Subject: Brunswick Steam Electric Plant, Unit Nos. 1 and 2  
Docket Nos. 50-325 and 50-324/License Nos. DPR-71 and DPR-62  
Request for License Amendment  
Revised Main Steam Isolation Valve Leakage Limit

**Evaluation of License Amendment Request**

**Subject: Request for License Amendment  
 Revised Main Steam Isolation Valve Leakage Limit**

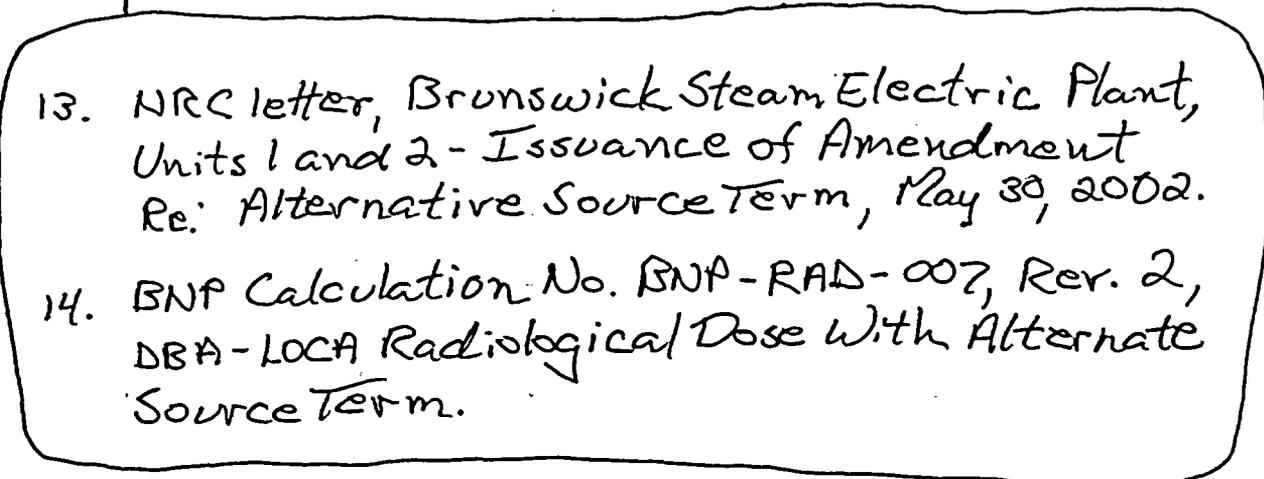
The analyses in References ~~2 and 5~~ are based on leakage that is less than the specified leakage rate. ~~Leakage through each MSIV must be  $\leq 11.5$  scfh when tested at  $\geq P_t$  (25 psig). The MSIV leakage rate must be verified to be in accordance with the leakage test requirements of the Primary Containment Leakage Rate Testing Program.~~ The Primary Containment Leakage Rate Testing Program has been established in accordance with 10 CFR 50.54(o) to implement the requirements of 10 CFR Part 50, Appendix J, Option B (Ref. 6), and conforms with Regulatory Guide 1.163 (Ref. 7) and Nuclear Energy Institute (NEI) 94-01 (Ref. 8) except for the following:

Leakage through each main steam line must be  $\leq 100$  scfh when tested at  $\geq P_t$  (25 psig). The combined leakage rate for all four main steam lines must be  $\leq 150$  scfh when tested at  $\geq 25$  psig in accordance with the Primary Containment Leakage Rate Testing Program.
